## Appendix 2

## National Highways responses to the Applicant's Document 18.2 (REP4-028)

Figure 1 – Realigned Taverham Road, dated 29 July 2020

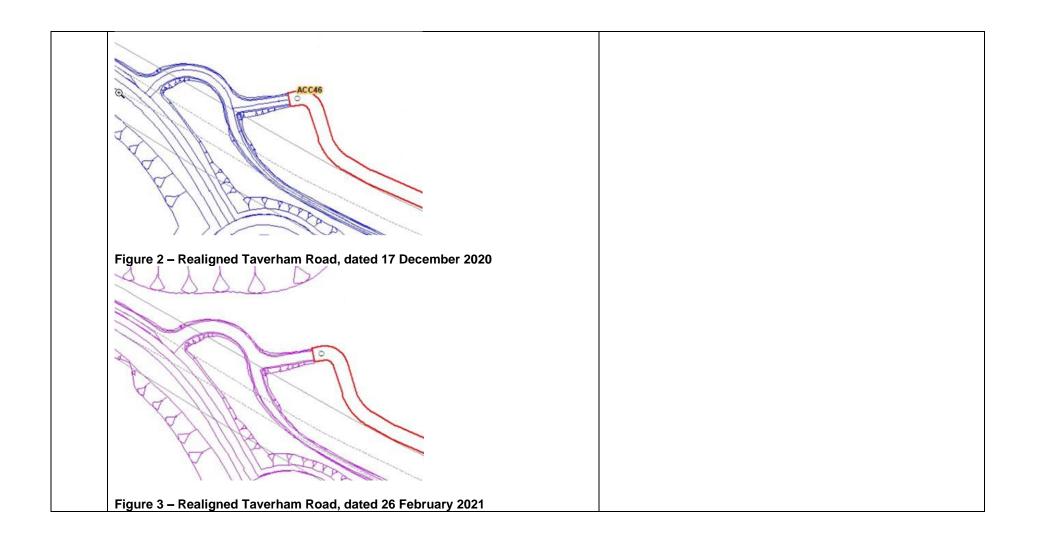
The Applicant notes that there is a misalignment between the Order limits and the realigned Taverham Road as mapped in plans secured by the A47 Tuddenham Scheme DCO.

Three versions of the A47 Tuddenham Scheme CAD files have been received by the Applicant from National Highways, dated 29 July 2020, 17 December 2020, and 26 February 2021 in the associated metadata (see Figure 1, Figure 2 and Figure 3 below). The Applicant's access at ACC46 from the realigned Taverham Road was designed based on the first version, dated 29 July 2020. The second version dated 17 December 2020 maintains the alignment as designed. However, the third version dated 26 February 2021 includes a small misalignment with the Order Limits at ACC46, due to an adjustment made to the A47 Tuddenham Scheme design, as noted by National Highways at ID18 below.

National Highways' view is that it is for the Applicant to design its scheme around the latest drawings available, which from the Applicant's response is clear were available in February 2021. National Highways' view is that this is a matter that does need to be addressed by the Applicant at the earliest opportunity given the potential knock-on impacts in this area for the interactions between the A47 TUD DCO and the Hornsea Project Three Offshore Wind Farm Order 2020.
